# Response to Referee Reports

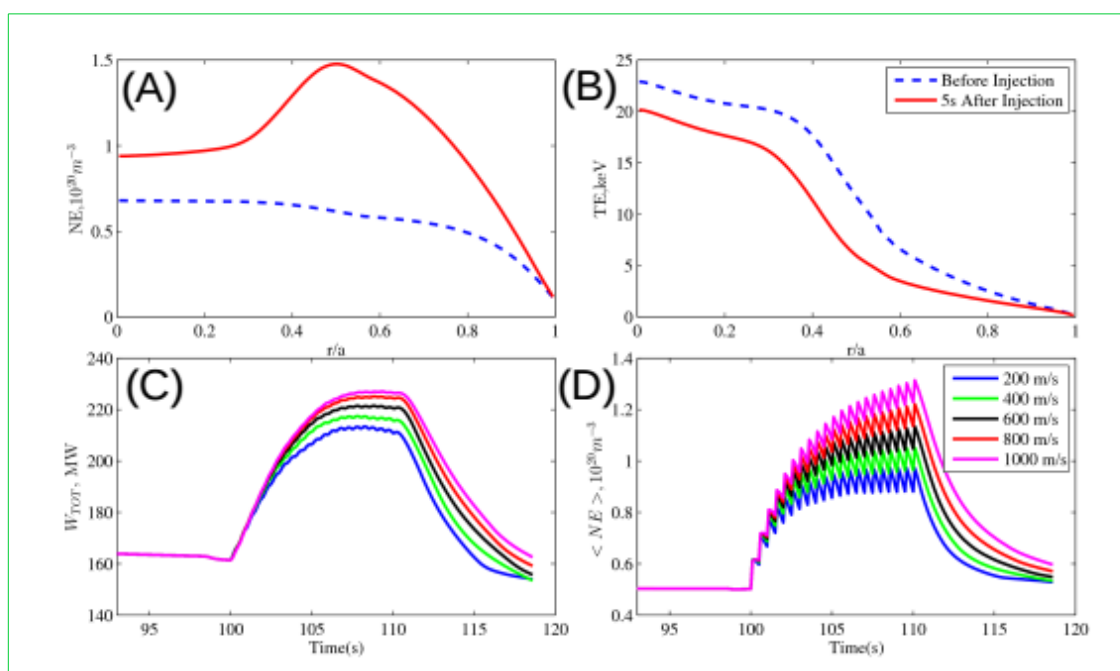
4. paragraph 3 "...we can see the degradation of temperature profile ..." means the temperature profile after pellet deposition should be lower than that before pellet deposition. However, Figure 1 B) does not satisfy the sentence.

-paragraph 4 "these graphs clearly shows ... greatly improve the plasma stored energy with more than 20-25 % change." What is "20-25%" compared with? The next sentence said that the difference in energy stored for pellet injected by 1000 m/s (highest) and 200 m/s (lowest) is just 5%. This then concludes that 200m/s is more or less enough because it makes no significant difference in energy stored if we changes injection velocity. So, what does "20-25%" mean?

Thank you for addressing this important issue . To show more clearly results and explanation , we decided to change our injection frequency from 0.5 Hz to 2 Hz and pellet size from 4 mm to 3 mm. The revised graphs and descriptions are showed below.

“Figure 1A and 1B shows the electron density and electron temperature profiles before the pellet injection and five seconds after pellet injections. Note that pellets with unity ratio between deuterium and tritium are launched with the injection frequency of 2 Hz, radius of 3 mm, and speed of 500 m/s. After pellets are released, it results in a sharp increase in the density profile near the edge and also lead to a peaked density near the normalized minor radius  $r/a = 0.5$ . On the other hand, we can see the degradation of temperature profile on both edge and core regions due to energy absorption in pellet ablation process.

Figure 1C and 1D shows the predicted temporal evolution of the total plasma stored energy and the line average of electron density when pellets are injected with frequency of 2 Hz, radius of 3 mm, and the injection speeds vary between 200 - 1000 m/s. These graphs show that pellets can increase the plasma stored energy up to 210-230 MW or 25-35% improvement compared with the plasma stored energy of 165 MW before the pellet operation. We found that there is only 10% difference in the energy stored in the plasma when the pellets were injected with 200 m/s and those injected with 1000 m/s. Thus, launching speed of 200-300 m/s is enough to improve the fusion performance by amount of 25%. In further research, pellet parameters (i.e. injection frequency, mixing ratios, injection angles) and plasma stability should be investigated to find more proper ways for fueling and control ITER plasma.”
